SUBJECT: Safety Recall **05S28** - Supplement **#10**
 Certain 1994-1996 Model Year Bronco, 1994-2003 F-150 through F-550, 1997-2002 Expedition, 1998-2002 Navigator, 2002-2003 Blackwood, 1994-1996 E-150/250/350, 1996-2002 E-450, 2002-2003 E-550, 2000-2003 Excursion, and 1998 Explorer and Mountaineer gasoline or natural gas engine vehicles equipped with Speed Control – Speed Control System Modification

New! REASON FOR SUPPLEMENT #10

Ford has determined that the following vehicles were built with the same system configuration as previously recalled vehicles:

FIGURE 5

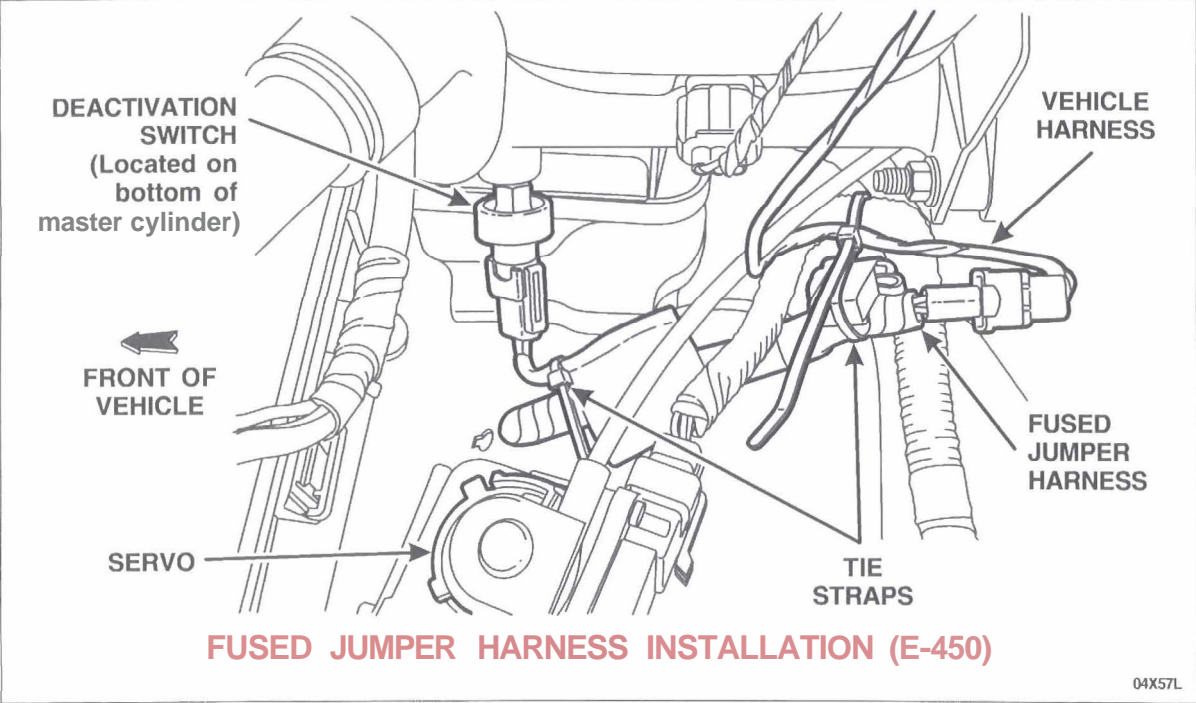
1. Connect the fused jumper harness (14A411) to the speed control deactivation switch and the vehicle harness.
- NEW** 2. **On E-450 models, secure the 2-wire take out to the larger portion of the fused jumper harness before installation, as shown in Figure 5.**

FIGURE 7

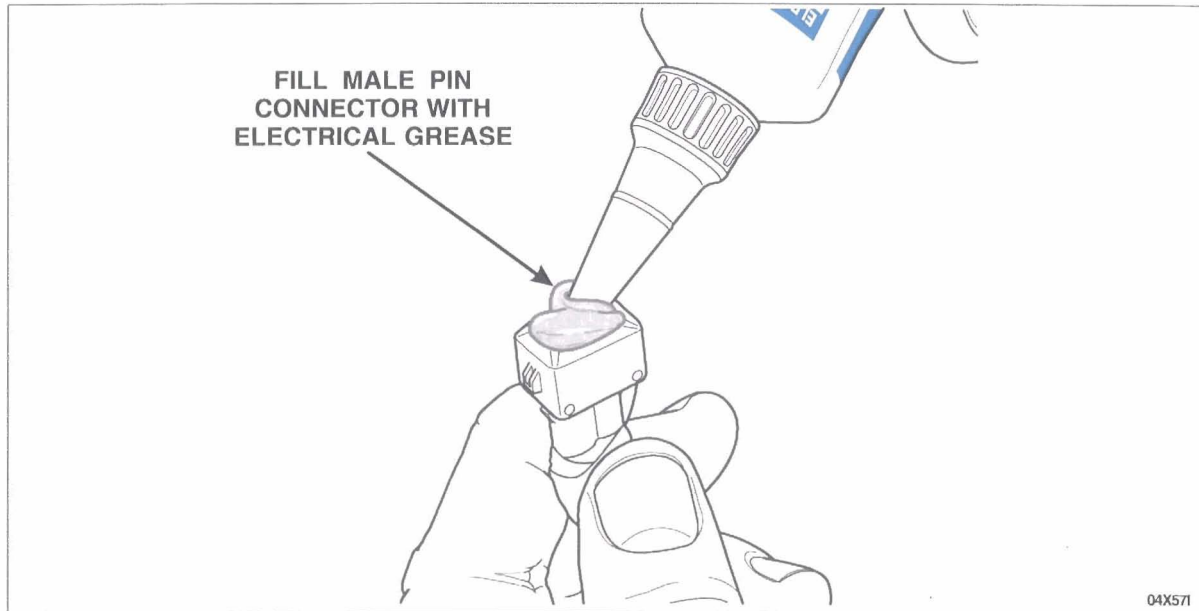
3. Install the **new** speed control deactivation switch into the master cylinder and tighten to 18 Nm (13lb-ft).
4. **With the speed control servo disconnected, use shop air only to blow the speed control deactivation switch harness electrical connector and the servo connector dry of any trace of brake fluid. DO NOT USE ANY TYPE OF SOLVENT TO CLEAN THE CONNECTORS.**
5. Cut approximately 3 mm (1/8 in) off the grease tube applicator tip.
- NEW** 6. Before installing the jumper harness, fill the vehicle harness end of the jumper (male pin connector end) with **Motorcraft** Electrical Grease II XG-15-A. See Figure 7.

FIGURE 10

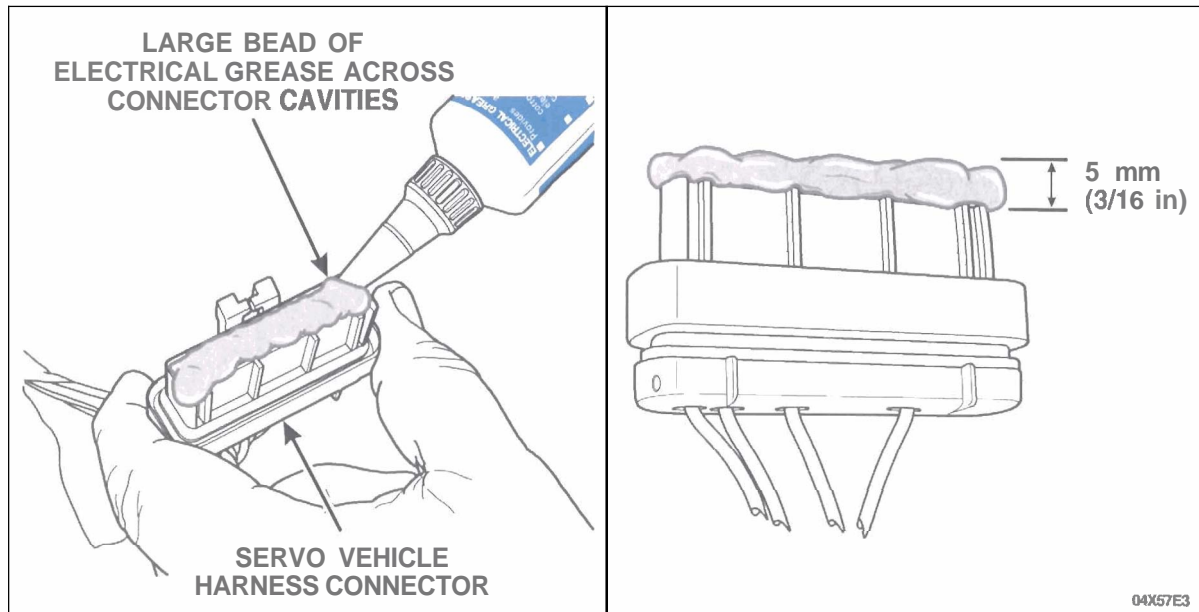
Apply a 5 mm (3/16 in) high bead of **Motorcraft Electrical Grease II XG-15-A** across the entire width and length of the servo vehicle harness connector. See **Figure 10**.
